SUBJECT: Submits explanation of failure of emergency svc water sys &  
 discussion of impact on plant performance. During recent  
 design activities associated w/mod, unidentified &  
 unevaluated single failure discovered in sys.

SUSQUEHANNA STEAM ELECTRIC STATION  
ADDITIONAL INFORMATION - ESW SYSTEM  
ER 100450 FILE 841-2  
PLA-1388

Docket No. 50-387

# ESW FIX - OPTION 1

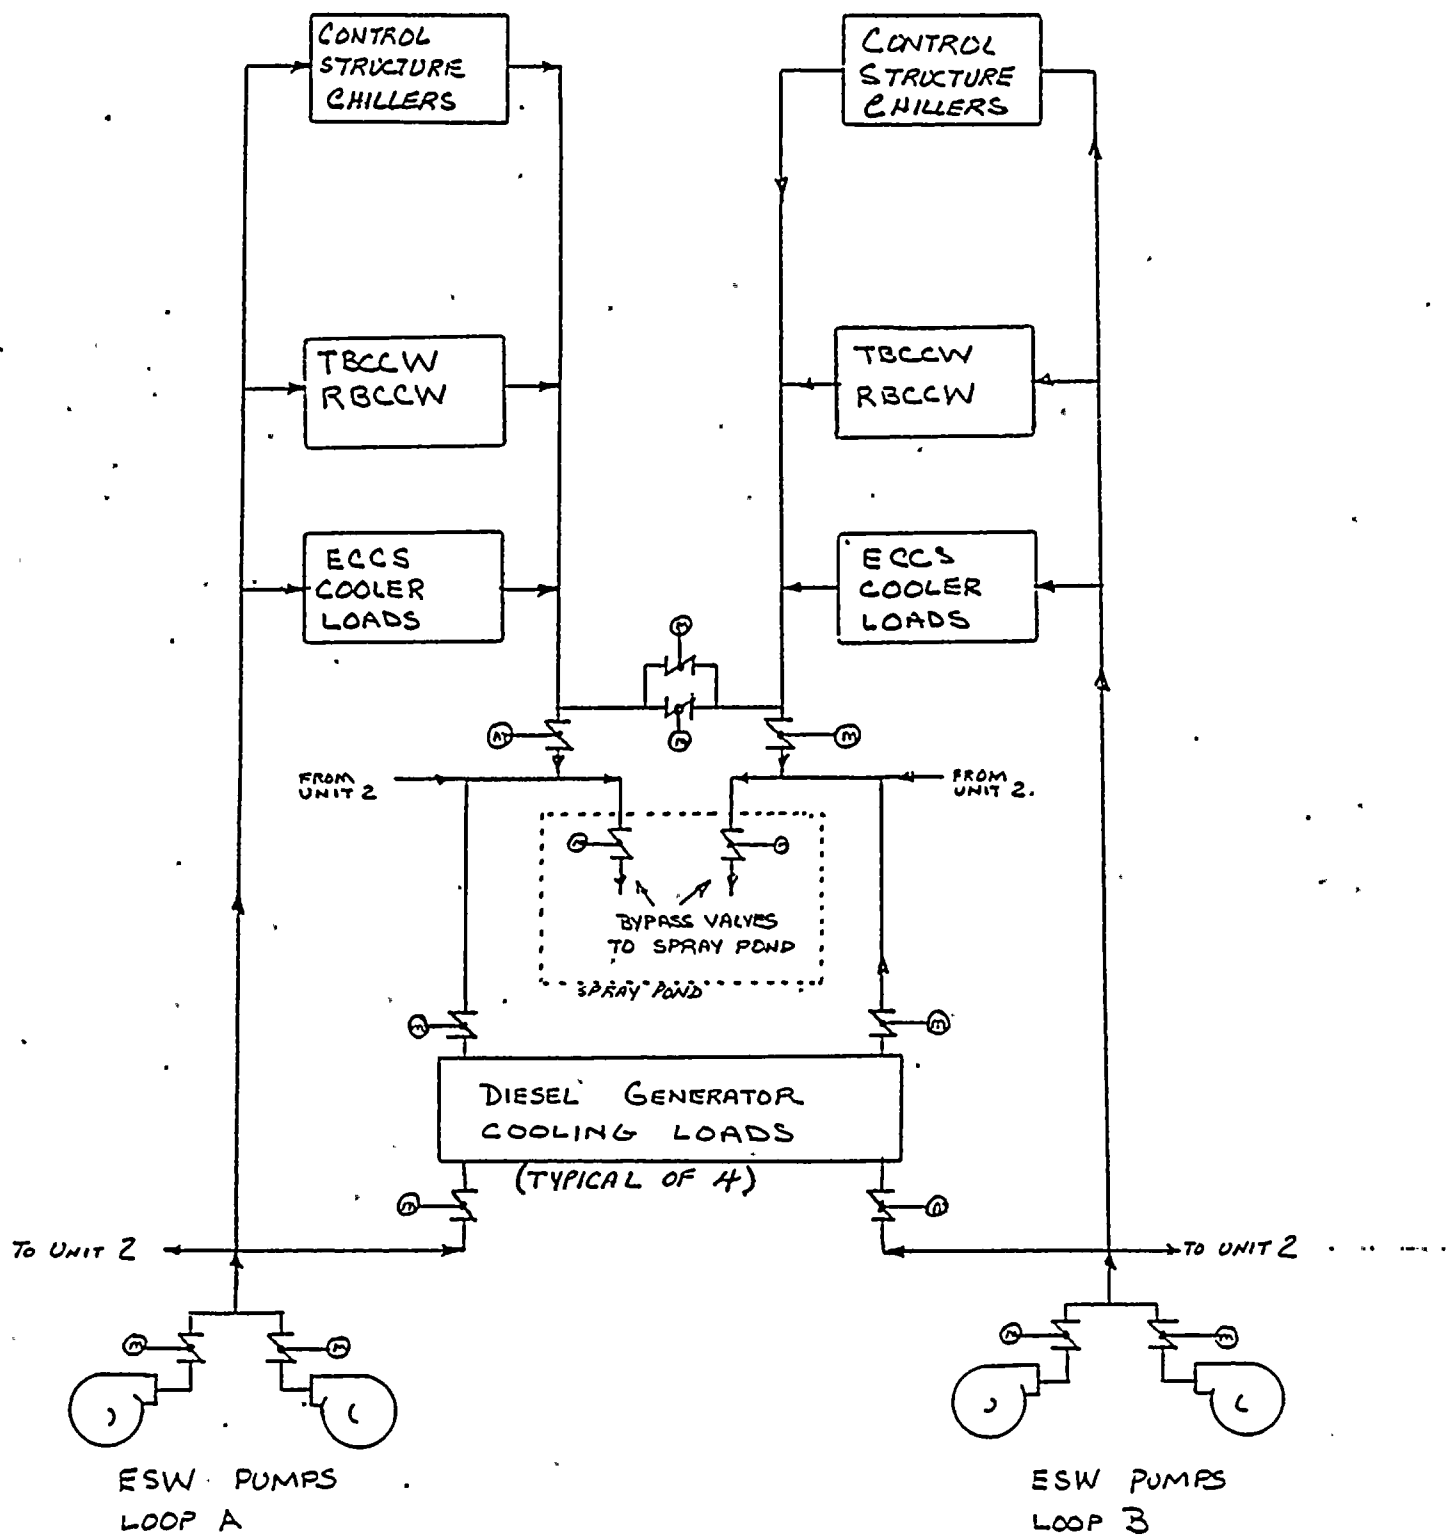
Option 1: This option would interconnect ESW Loop A & B return loops to provide a flow path through the alternate bypass valve if either one fails. Drain down protection is also provided through installation of additional valves.

The ESW discharge valves (powered off separate power supplies) are jogged open 7° upon pump start and fully opened once the system is filled. The bypass valves remain closed until 120 sec's after ESW pump start. The interconnection between ESW Loop A and Loop B is provided to address failure of a bypass valve to open. This interconnection has parallel isolation valves powered off of separate power supplies. Additional ESW Loop A and Loop B valves are provided to prevent waterhammer given failure of a bypass valve to close. The additional valves are provided separate power supplies. Valve transfer is accomplished on flow signals. Automatic transfer from ESW Loop B to Loop A would be incorporated in the design.

# ESW FIX - OPTION 2

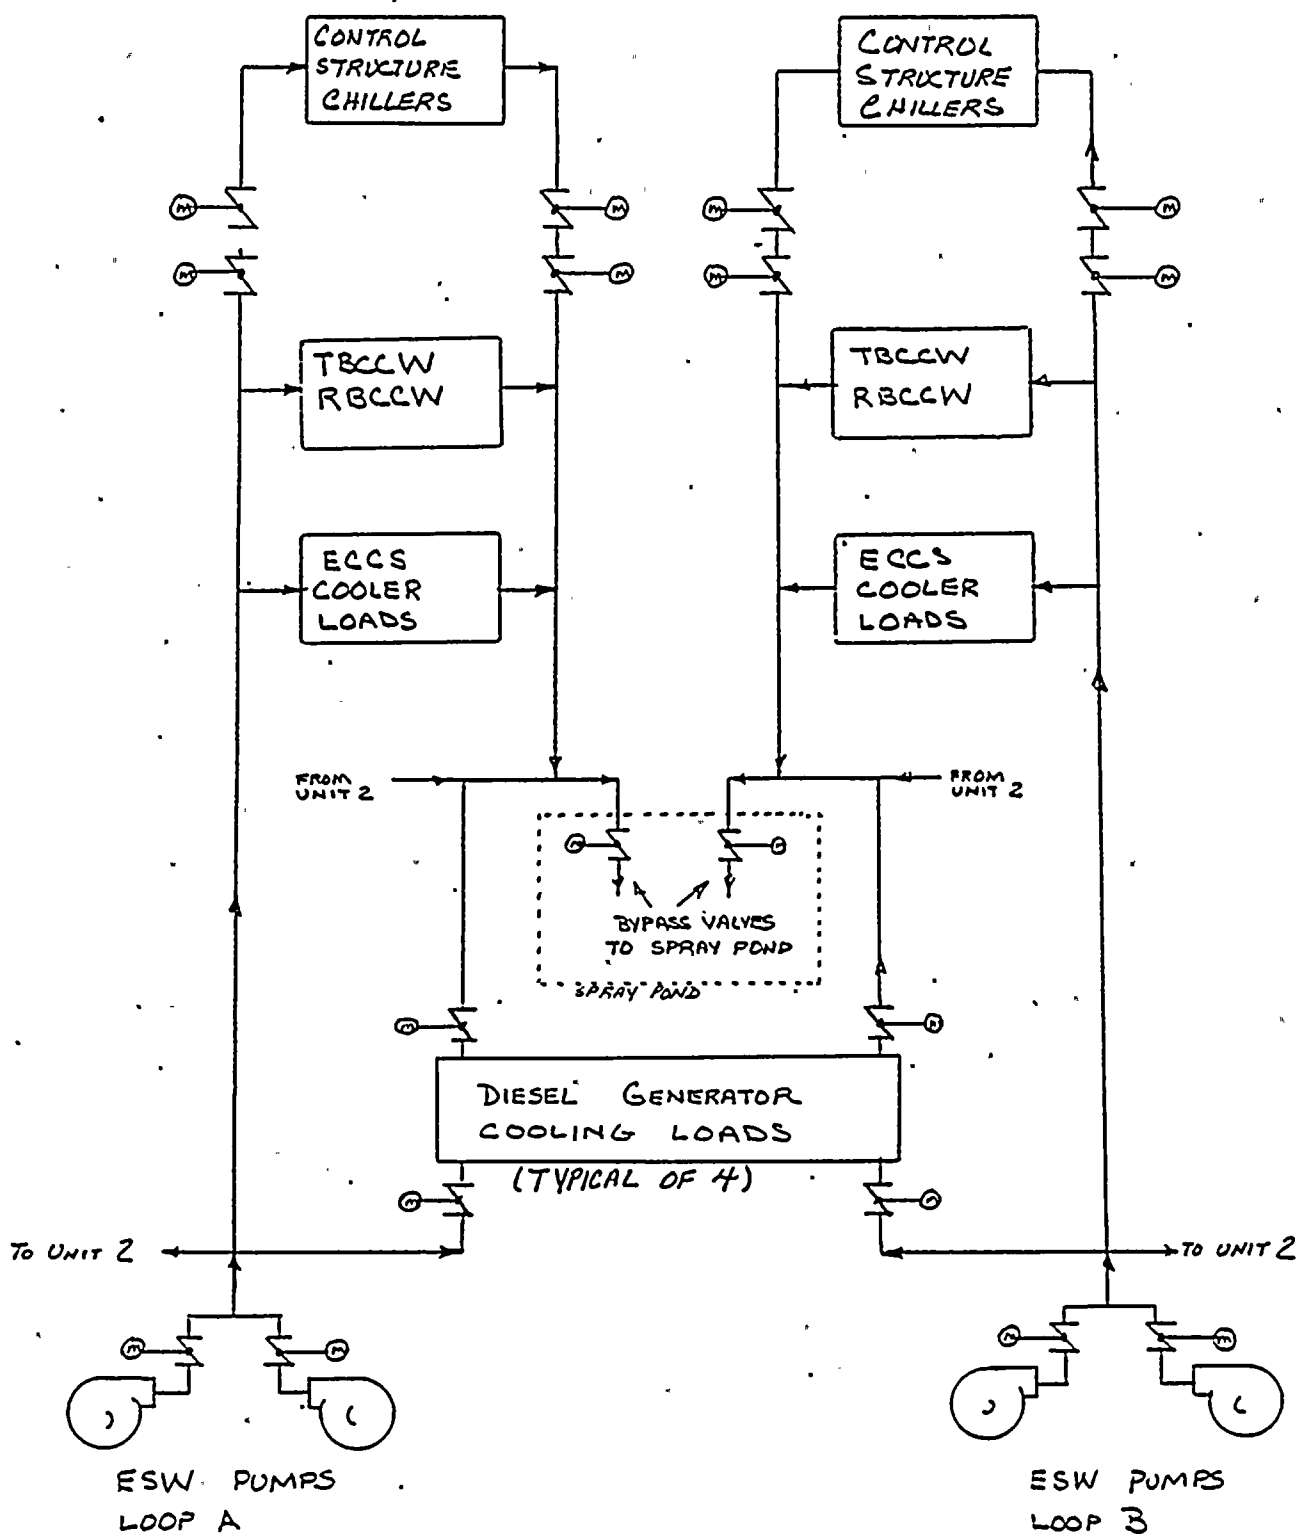
Option 2: This option would keep the ESW discharge valves and bypass valves open at all times.

Isolation of the vertical sections of supply and return piping is provided to avoid drain down with normally closed series valves powered off different power supplies. The isolation valves on ESW supply are jogged open until a pressure switch at the ESW Loop highpoint picks up allowing the valves to fully open. Failure of one of the supply valves to open will result in loss of flow to the control structure chillers on the failed loop. This is acceptable as the control structure chillers require only 1 of 2 ESW loops for cooling. Automatic transfer from ESW Loop B to Loop A would be incorporated in the design.
